panthera®

Info sheet 2012-01

New standard hub

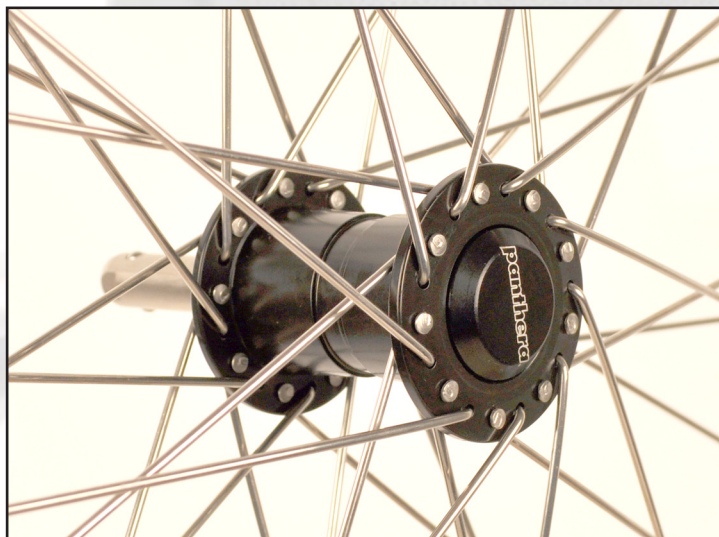
The new hub features a new design and a different alloy of aluminum. Also the axle has a new design. The new rearwheel axle is backward compatible with the old hub and the old rearwheel axle will fit the new hub.

The new hub is easily recognized by the black color and wheel axle of the beveled button and the laser-written Panthera logo.

Hubshell with bearings art.no. 1700070
Axle QR 1/2" / 12,7mm x 91 mm SJ art.no. 1100022
